Executive Summary Downtown Project Authorization

Date: August 6, 2015
Case No.: **2013.0159X**
Project Address: **525 HARRISON STREET**
Zoning: RH-DTR (Rincon Hill Downtown Residential) Zoning District
Existing Height/Bulk: 65-X & 65/400-R Height and Bulk District
Proposed Height/Bulk: 65-X & 65/250-R Height and Bulk District
Block/Lot: 3764/063
Project Sponsor: Steve Vettel, Farella Braun + Martel, LLP
235 Montgomery Street
San Francisco, CA 94104
Staff Contact: Richard Sucre – (415) 575-9108
richard.sucre@sfgov.org

The proposed project includes demolition of the existing two-story former industrial building (27,500 gsf), and the new construction of a 23-story residential building (approximately 255,468 gross square feet; up to 250-ft tall) with up to 205 dwelling units, 1,000 square feet of ground floor café/retail, 103 off-street parking spaces, 127 Class 1 bicycle parking spaces, and 20 Class 2 bicycle parking spaces. The project includes a dwelling unit mix consisting of 94 two-bedroom units, 69 one-bedroom units, and 42 studio units. The proposed project includes approximately 15,683 square feet of open space via ground floor street improvements, private balconies, a podium

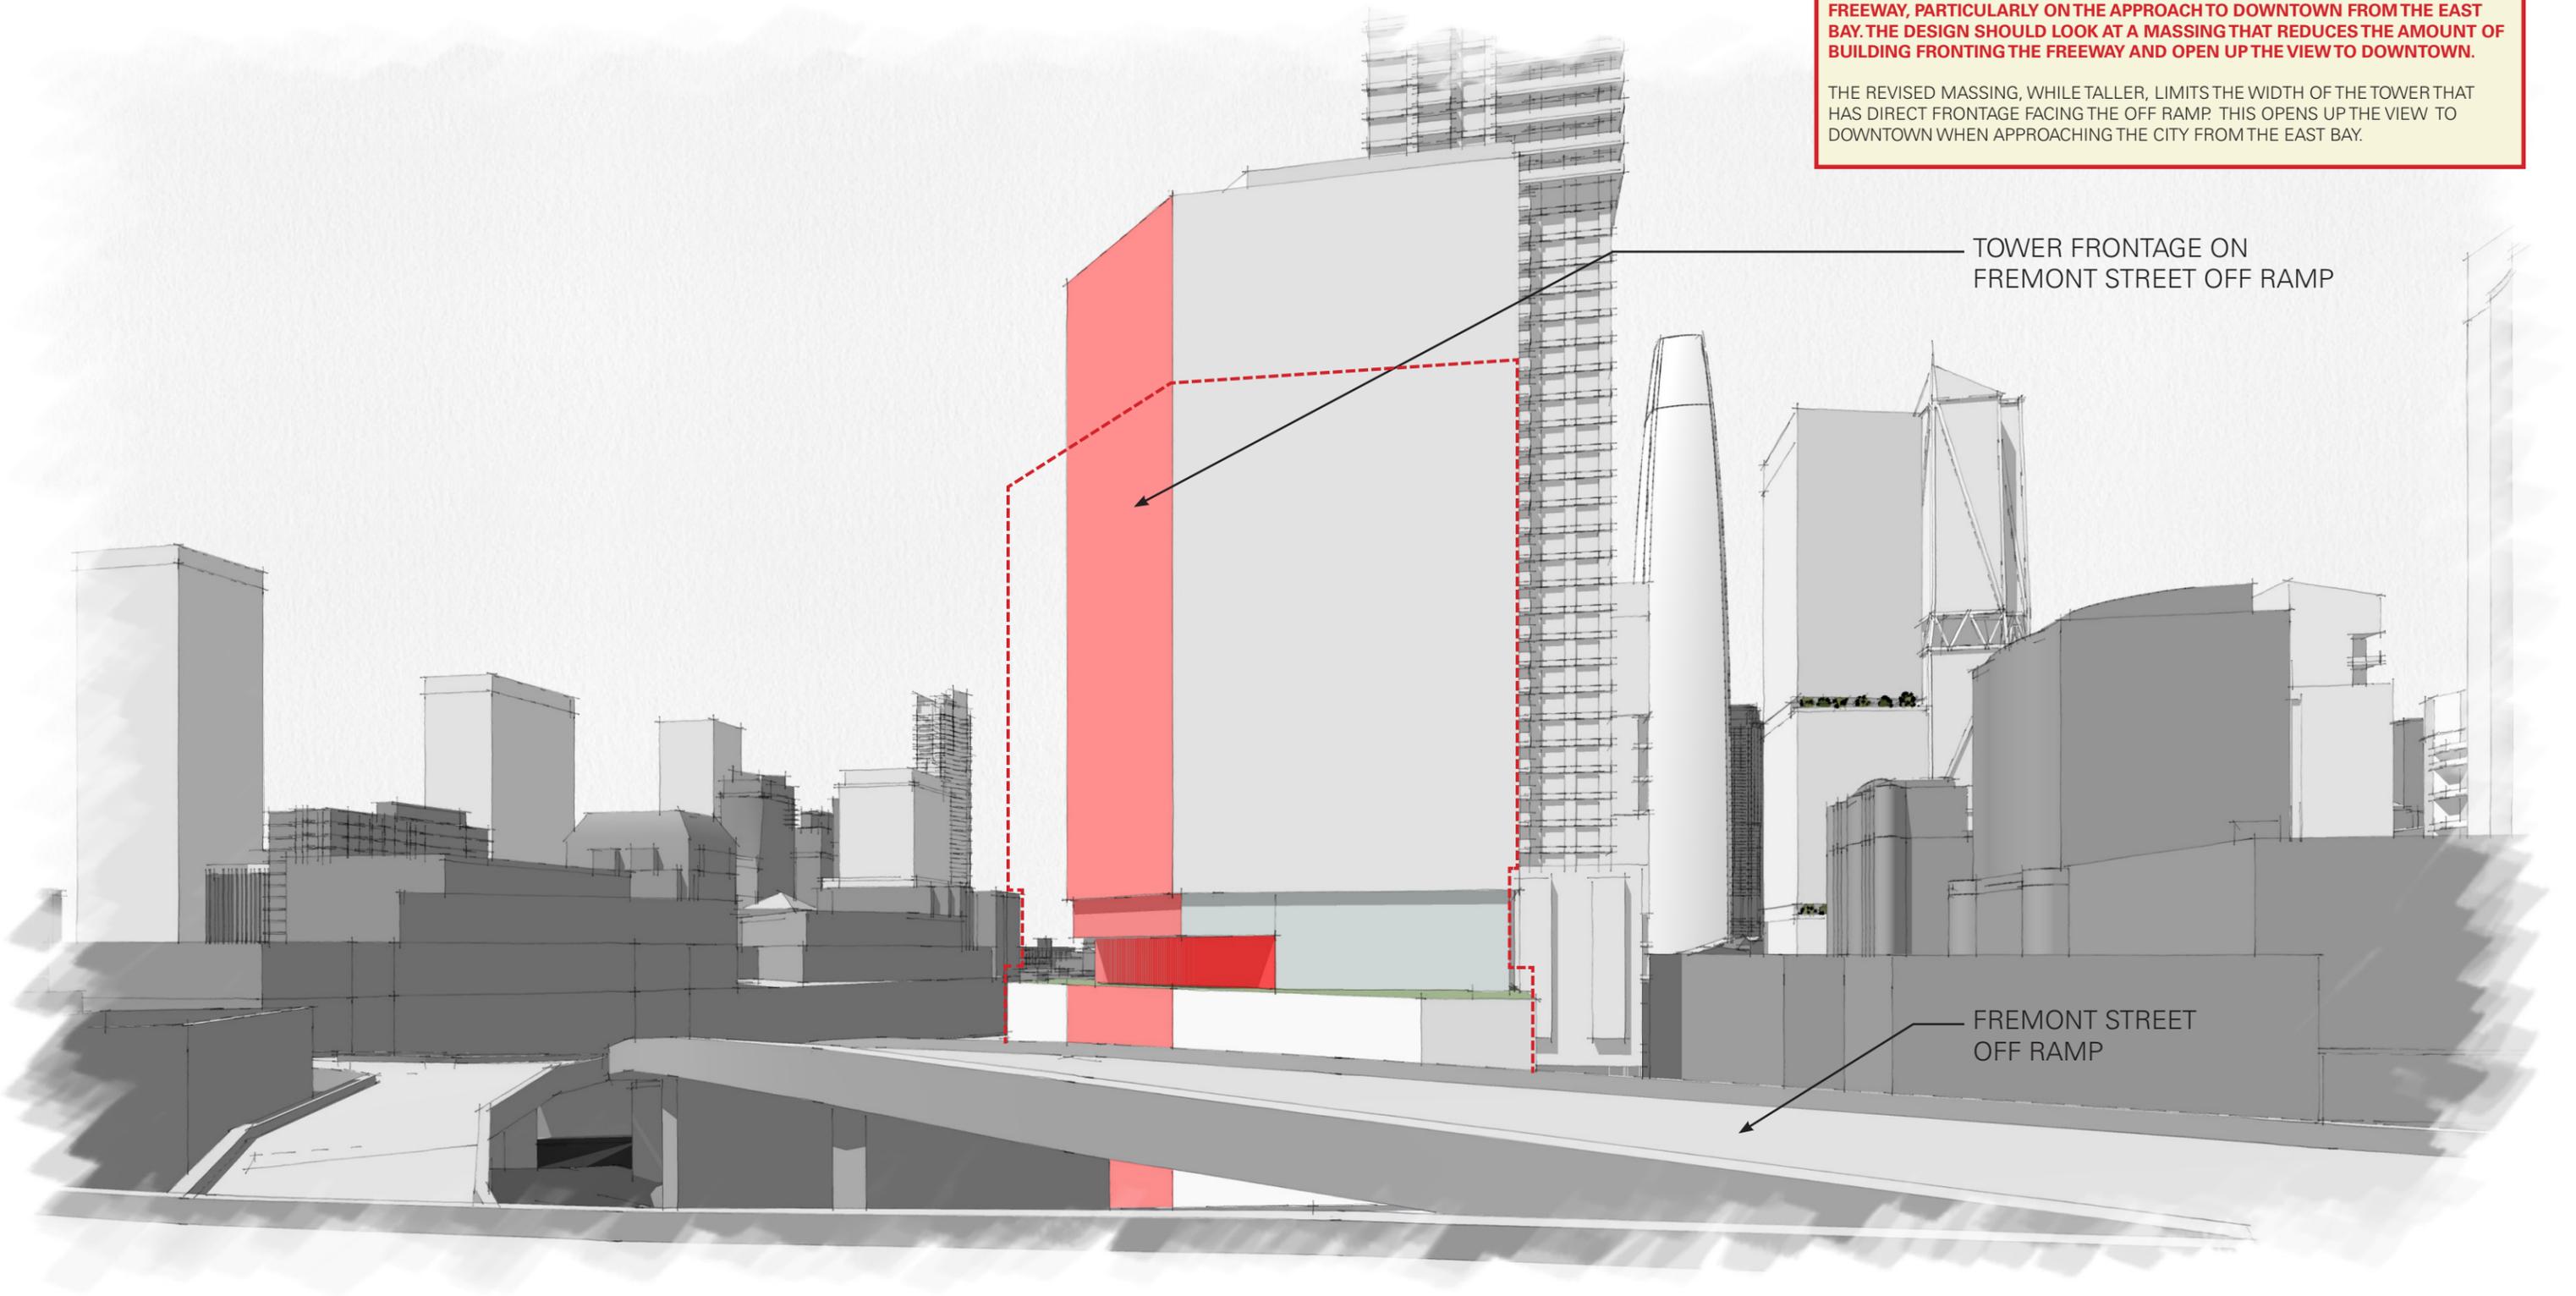
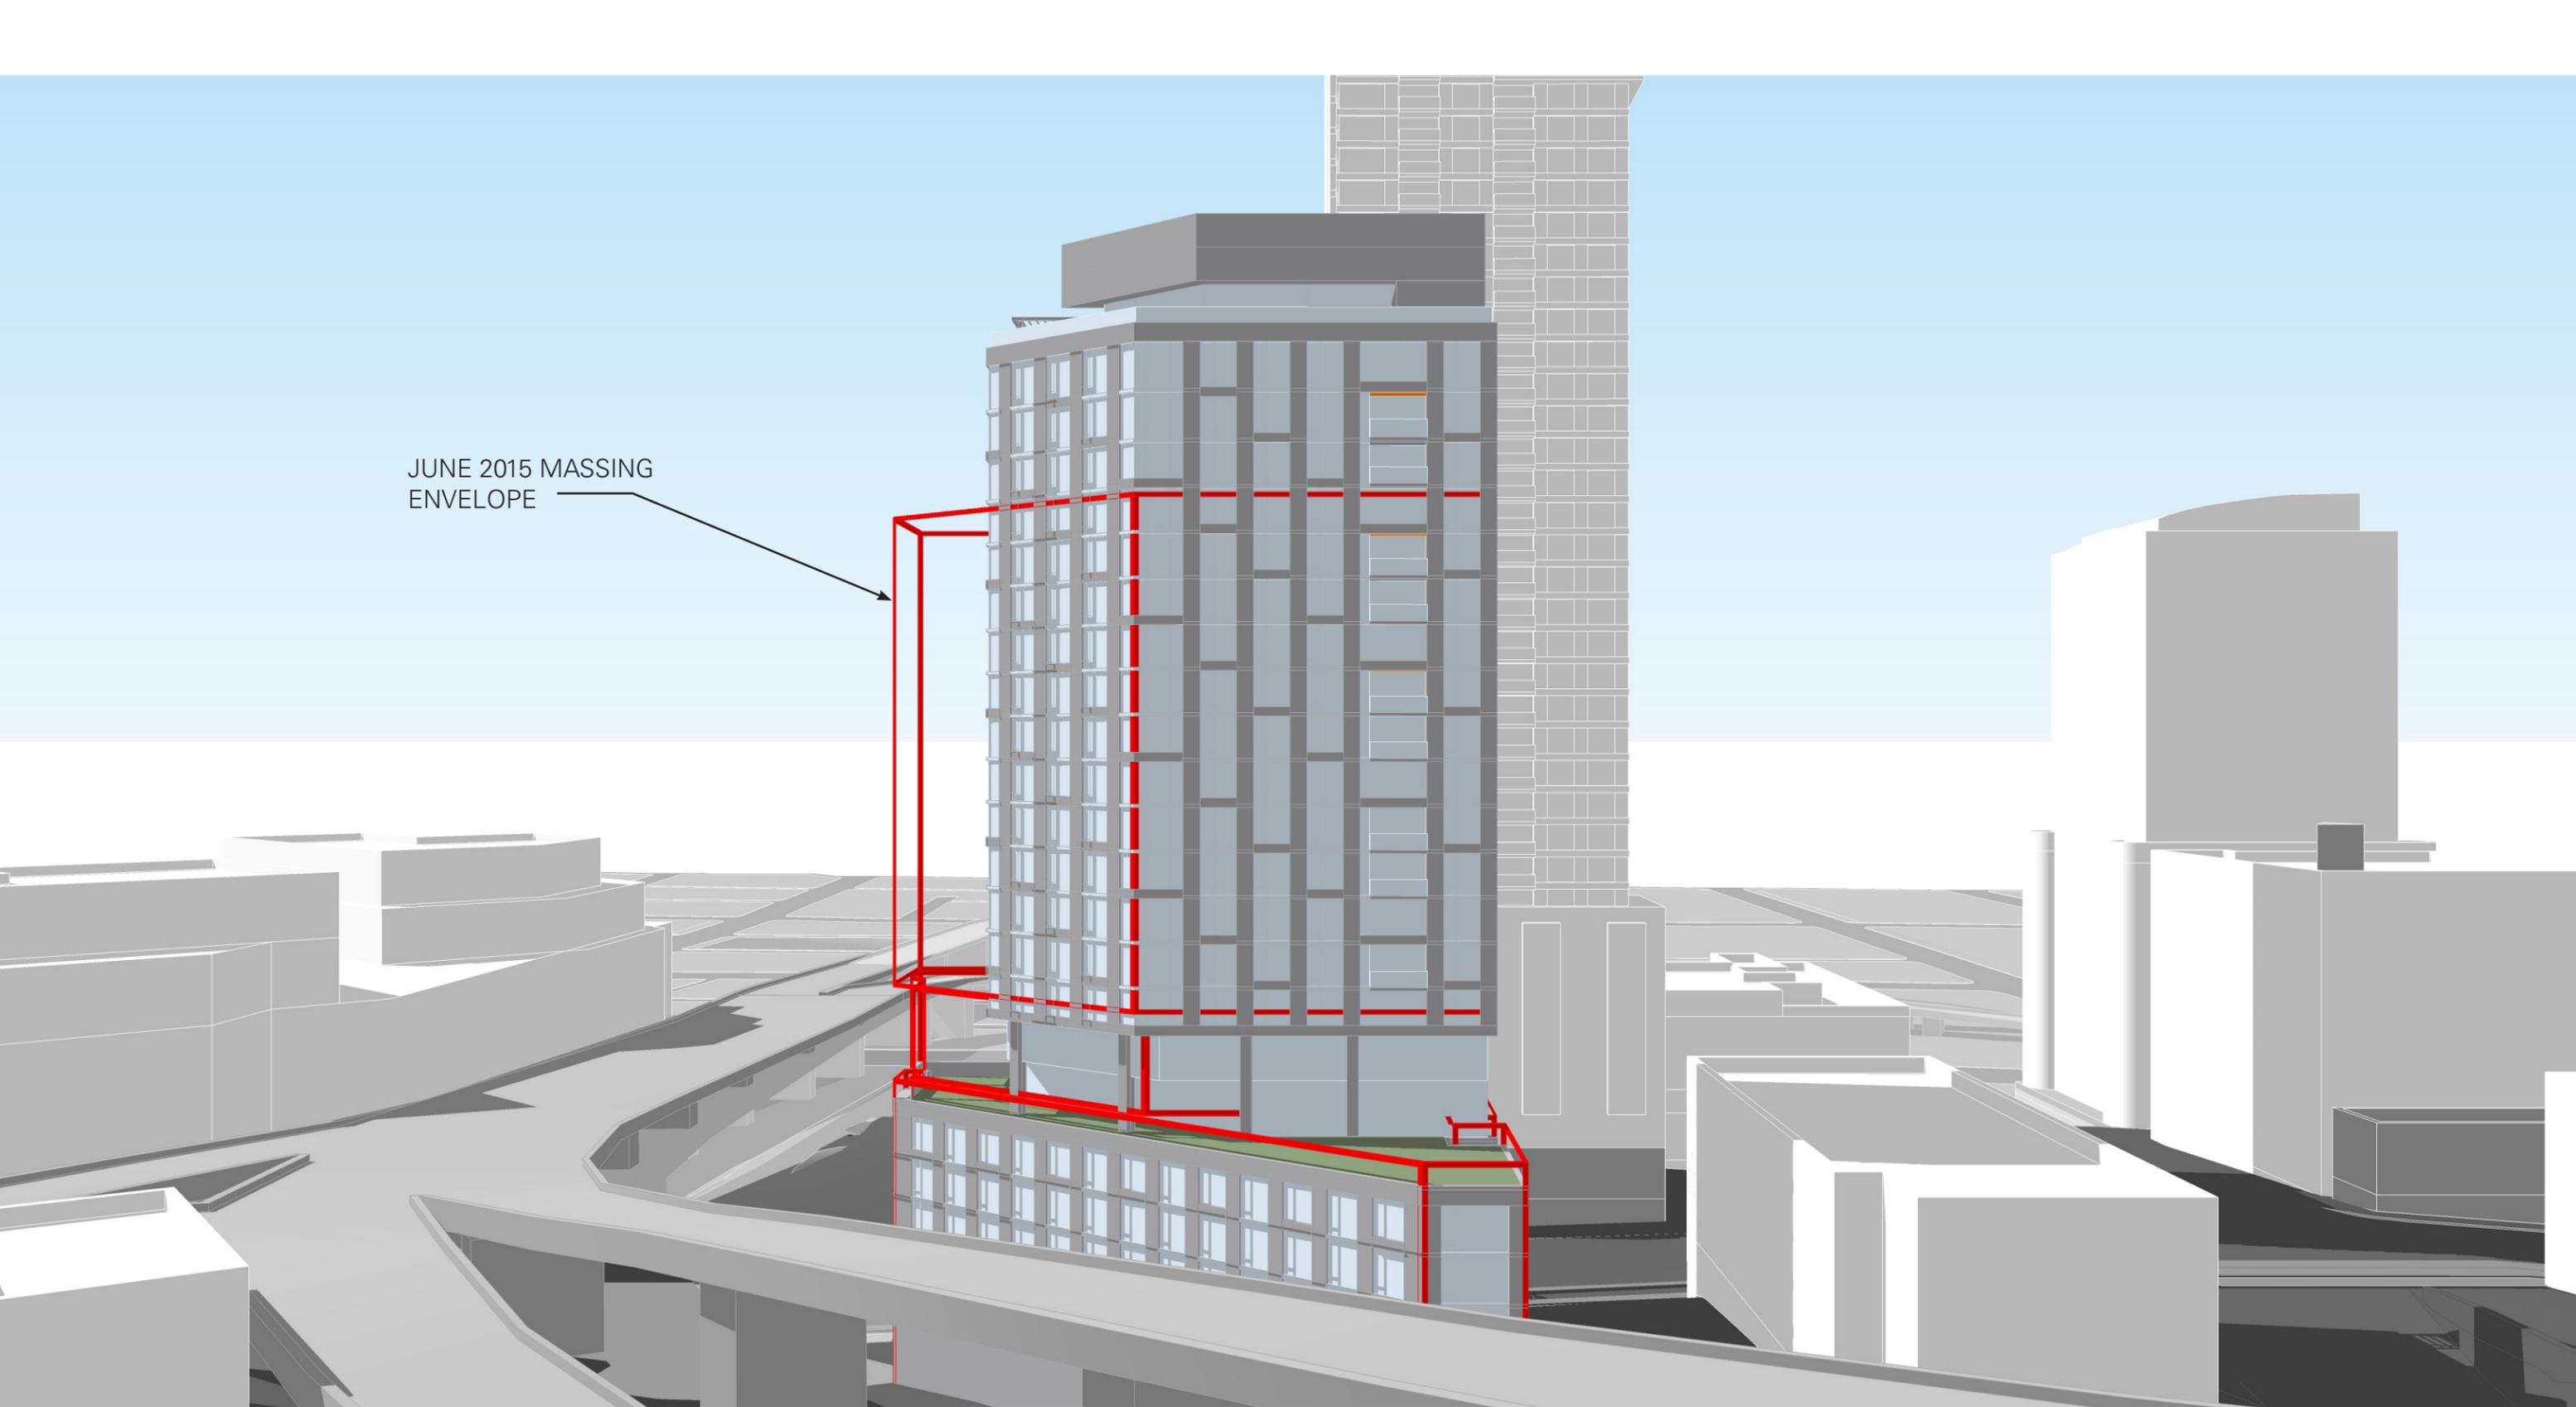
PLANNING COMMISSION COMMENT: THE BUILDING IS HIGHLY VISIBLE FROM THE FREEWAY, PARTICULARLY ON THE APPROACH TO DOWNTOWN FROM THE EAST BAY. THE DESIGN SHOULD LOOK AT A MASSING THAT REDUCES THE AMOUNT OF BUILDING FRONTING THE FREEWAY AND OPEN UP THE VIEW TO DOWNTOWN.

THE REVISED MASSING, WHILE TALLER, LIMITS THE WIDTH OF THE TOWER THAT HAS DIRECT FRONTAGE FACING THE OFF RAMP. THIS OPENS UP THE VIEW TO DOWNTOWN WHEN APPROACHING THE CITY FROM THE EAST BAY.

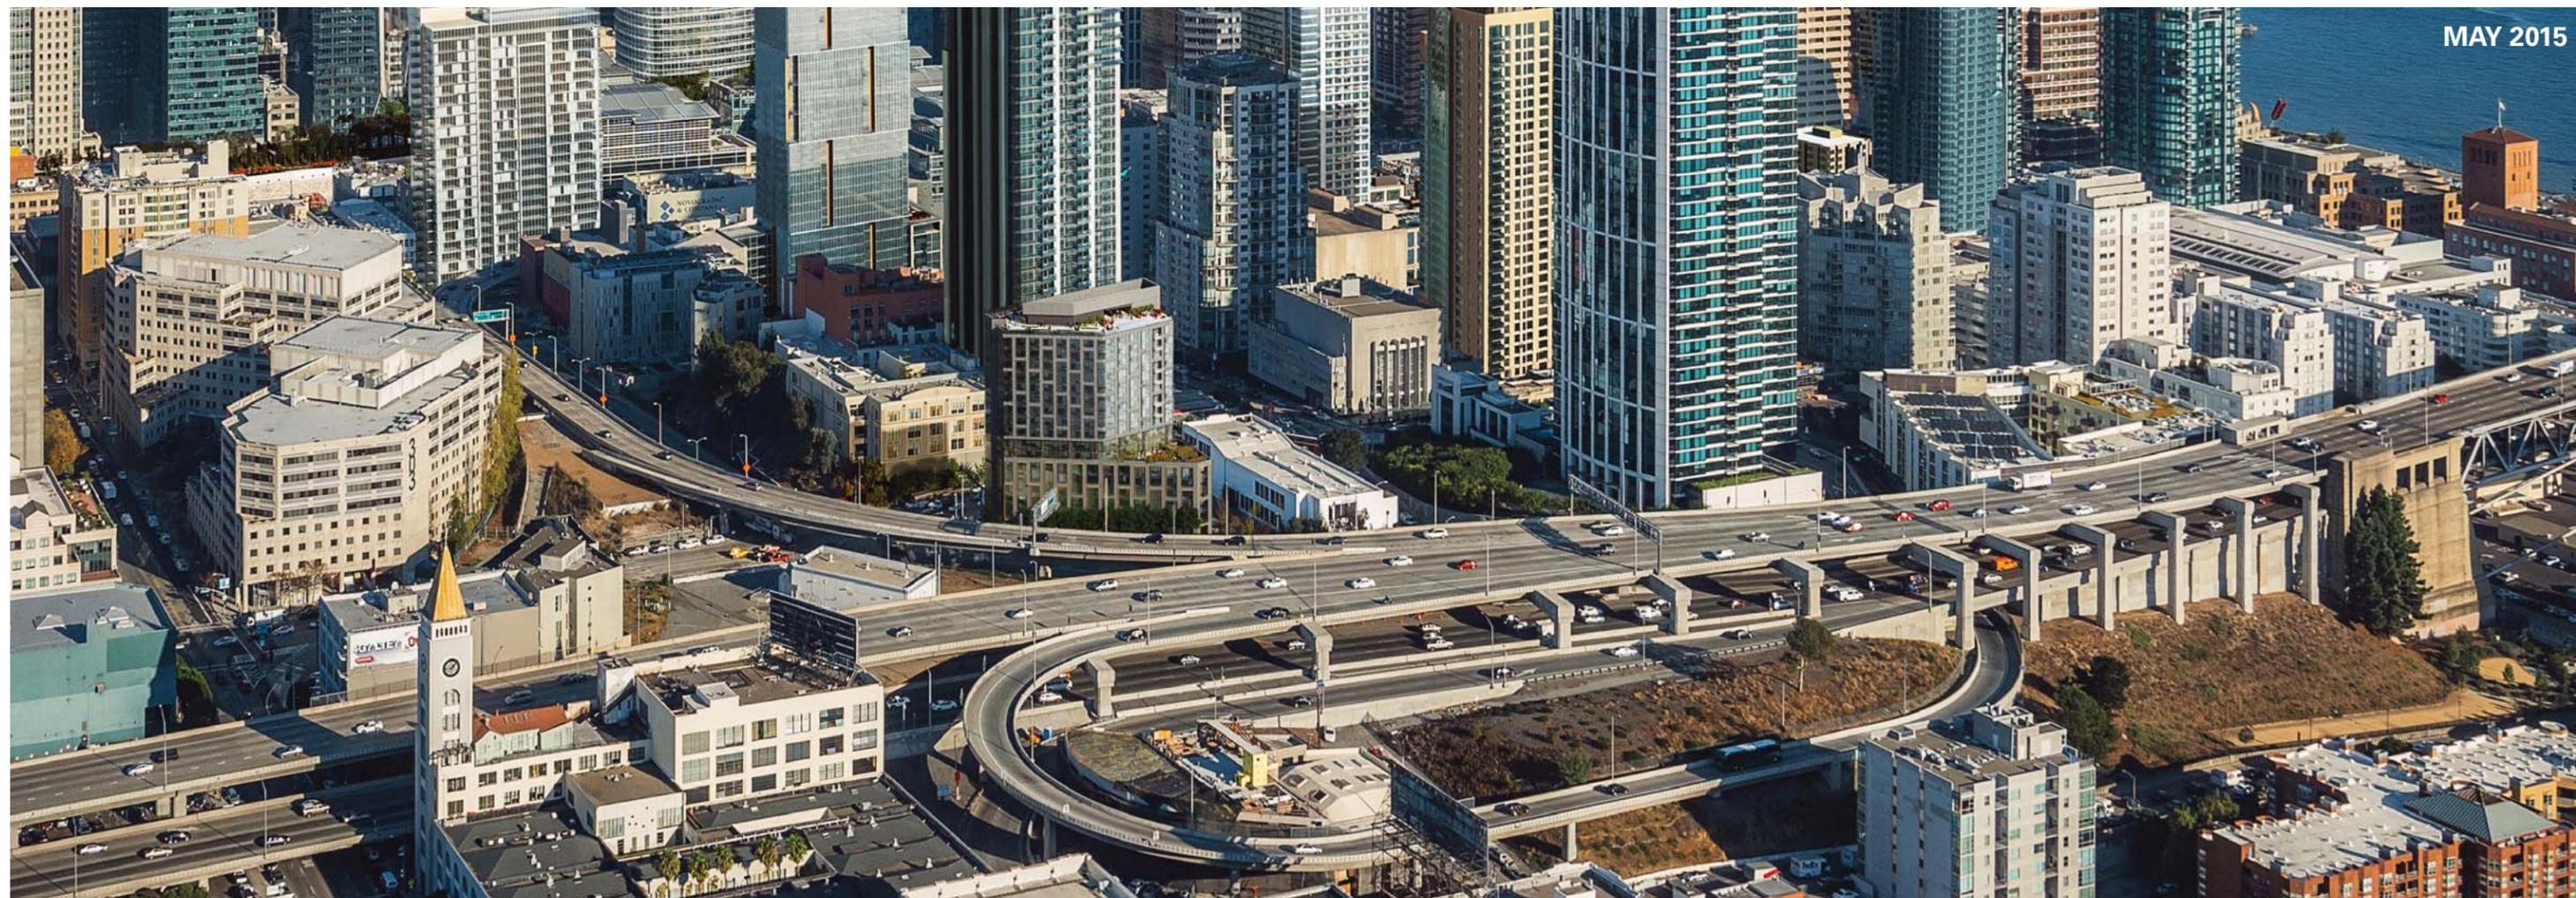
NOTE: Planning Department requested that the design team look at the resulting mass within the context of the city. Supported by the presented exhibits, the building is not a "skyline" building and is not visible from the water, the East Bay, or the Bay Bridge. Approaching the city from the East Bay on the freeway, the building does not come into view until you are past One Rincon Hill. At this point, the building is of similar scale and massing to many of the older surrounding buildings. This contextual approach to the site proved non-controversial when presented to the neighborhood groups affected by the project.

ELEVATIONS APPROVED BY UDAT, **MAY 2015**

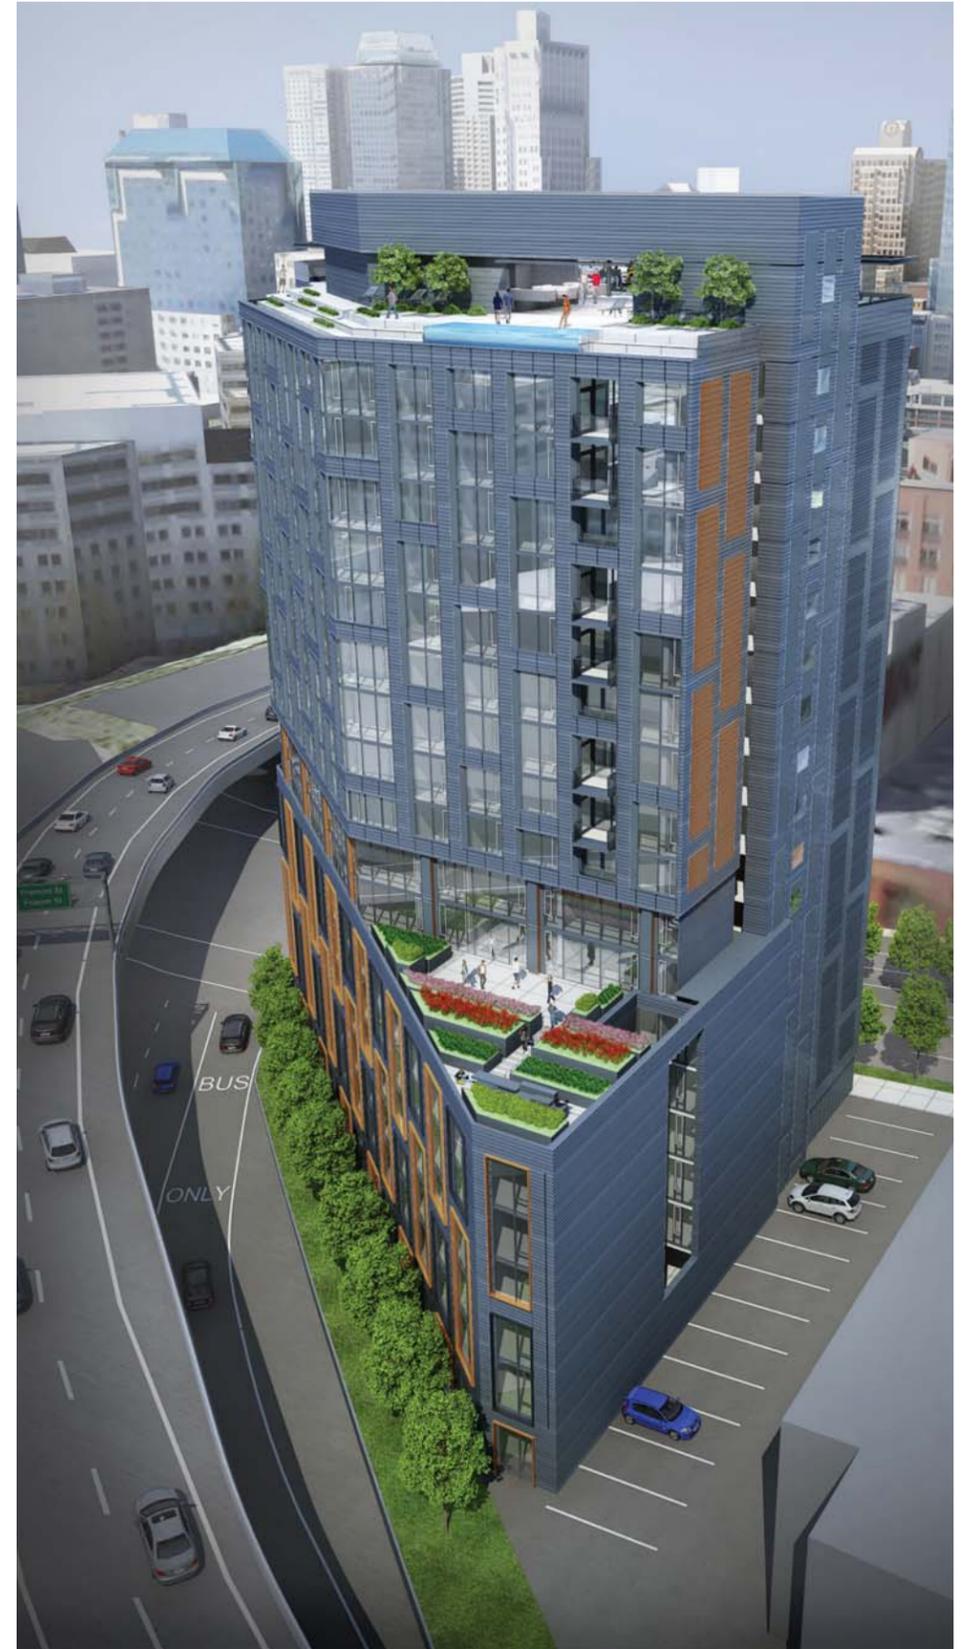
NOTE: UDAT requested that the massing be broken up along Harrison Street. In keeping with the Rincon Hill Plan, the goal was to create a series of three, more slender volumes, versus a single broad volume.

NOTE: The Planning Director requested a lighter material be considered for the facade. The design team investigated several versions which balance this request with the industrial masonry design intent, and the reality of lighter building materials in proximity to the freeway.
